TECHNICAL MEMO

Subject: Preliminary Hydrology Study

Project: San Bernadino County Sheriff EVOC Paving Project

Date: November 30, 2022

EXISTING CONDITION EXHIBIT

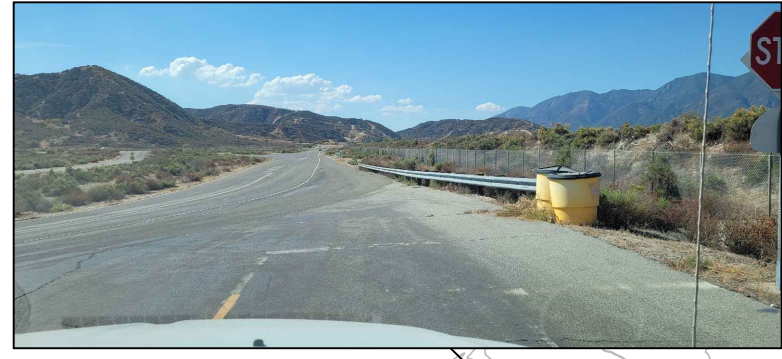
1. Offsite drainage from north of perimeter fence is flowing through the project site via a "natural stream" transporting sediment downstream through the project site. Heavy loads of sediment are suspended and transported by the water flow and settles at the outlet area. (See Existing Condition Exhibit Location #1). The concerns are further discussed in observations #2 and #3.

2. The "natural stream" along the east side of the project site was formed by the off-site storm run-on. The slope and depth of the stream cannot contain all the water during a heavy rain event. Location #2 is located at approximately the midpoint of the easterly edge. Storm runoff will flood over the pavement when the natural stream is over capacity. (See Existing Condition Exhibit Location #2)

Institution Road. Due to the flat slope at the outlet area, sediment is accumulated with soil erosion caused by rain and with storm runoff that transports sediment particles into the channel. Overtime, sediment will block the outlet and storm runoff will flood over the top of curb. (See Existing Condition Exhibit Location #3)

4. During our field investigation, a retention pond was observed at the north side of the project site. According to the Grading Plan prepared by W. R. Hendrix Engineering & Associates, dated April 17, 1991, an existing power pole should be removed and relocated, and no proposed retention basin was proposed at the north side of project site. Based on the proposed grading contours shown on the Grading Plan As-built, offsite drainage should be flowing towards the swale along the west side of project site. However, a portion of offsite drainage is draining towards the east side, which is causing drainage issue as discussed in observations #2 and #3 above. (See Existing Condition Exhibit Location #4 and Grading Plan As-built C-3)

5. The existing swale, culvert, and underground pipes along west side of project site have not been maintained properly. Vegetation and sediment are occupying the capacity of drainage facilities. Runoff may overflow into the site during a heavy rain event. (See Existing Condition Exhibit Location #5)

LOCATION #1
OBSERVATION #1: OFFSITE DRAINAGE

LOCATION #2
OBSERVATION #2: STORM RUNOFF FLOOD OVER THE PAVEMENT

LOCATION #3
OBSERVATION #3: SEDIMENT ACCUMULATES

LOCATION #4
OBSERVATION #4: EXISTING POWER POLE AND PONDING AREA

LOCATION #5
OBSERVATION #5: EXISTING DRAINAGE FACILITIES ARE LACK OF MAINTENANCE

In order to prevent the sediment depositing at the outlet area, IMEG recommends constructing a 2 ft. wide bottom, 1 to 1 side slope, trapezoidal vegetated swale along the chain-link fence at the east side of project site. The swale will begin at the northeast corner (See Location #1) of the project site and have a 2% minimum slope in the direction of flow. Areas requiring cut and fill can modify the slope to keep the top of swale lower than the adjacent pavement.

San Bernardino County Hydrology Manual does not require the off-site drainage to be mitigated. However, because it is transporting heavy loads of sediment, IMEG recommends rerouting the drainage to the existing retention pond via a graded swale (See Location #4), which will function as a sediment basin. Sediment from off-site drainage will be captured and settled in the basin, once the storm water accumulates to the basin's ponding depth limit, it will breach the top and overflow to the existing swale along the west side of the project site. Per Grading Plan As-built, the offsite drainage was bypassed through the existing swale along the west side of the project site. Based on this understanding, it can be assumed the existing swale should have enough capacity to convey the storm water. Please note that a formal hydraulic analysis should be performed to verify its capacity should the County decide to proceed with this recommendation.

According to the site investigation, the existing drainage facilities have not been maintained properly. IMEG recommends to remove the accumulated sediment and maintain the existing swales, underground pipes, and retention ponds on-site on an ongoing basis following an established routine schedule. It is important to keep all these facilities functional to ensure their design flow capacities.
